Access Compliance Report Public Rights-of-Way (Curb Ramps)

Main Street: MONTECITO_RD Cross Street: SHAKESPEARE_DR Location: NW

ADA ID: RPRK211215130543 Ramp Type: Type 1 - Perpendicular Diagonal Initial Pass/Fail: Fail Overall Compliance: No Severity Score: 15

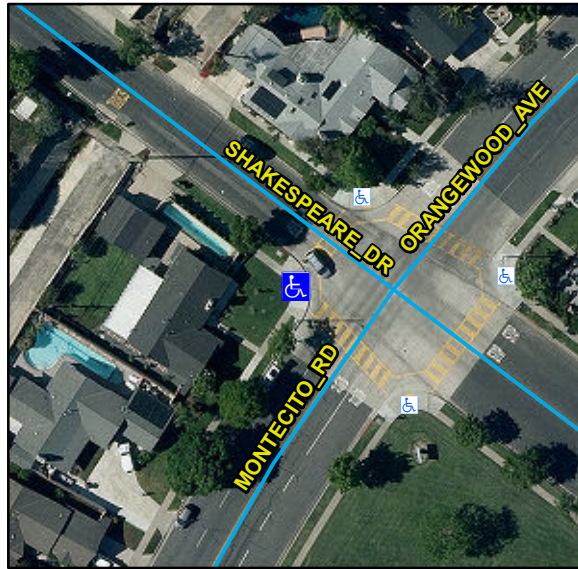
Compliance	Description	Data	Compliance	Description	Data
N/A	Ramp Length (in)	63	N/A	Flare Type LT	
Yes	Ramp Width (in)	48			N/A
No	Ramp Run Slope (%)	9.7	N/A	Flare Slope LT (%)	N/A
Yes	Ramp Cross Slope (%)	0.4	N/A	Flare Traversable LT	N/A
N/A	Landing Present	N/A	N/A	Flare Type RT	
N/A	Landing Length (in)	N/A			N/A
N/A	Landing Width (in)	N/A	N/A	Flare Slope RT (%)	N/A
N/A	Landing Run Slope (%)	N/A	N/A	Flare Traversable RT	N/A
N/A	Landing Cross Slope (%)	N/A	N/A	DWS Provided	N/A
N/A	Landing Movement Obstructed?	N/A	N/A	DWS Contrast	N/A
	Landing Movement Type	N/A	N/A	DWS Length (in)	N/A
N/A	Landing Shared	N/A	N/A	DWS Full Width	N/A
N/A	Clear Space	Yes	N/A	DWS Offset Left (in)	N/A
N/A	Clear Space To Crosswalk (in)	48	N/A	DWS Offset Right (in)	N/A
N/A	Marked Crosswalk 1	Yes	N/A	Marked Crosswalk 2	Yes
	Crossing 1 Direction	SE		Crossing 2 Direction	NE
	Marked Crosswalk 1 Width (in)	144		Marked Crosswalk 2 Width (in)	144

Remove & Replace Curb Ramp With Two New Directional Ramps or Equivalent.
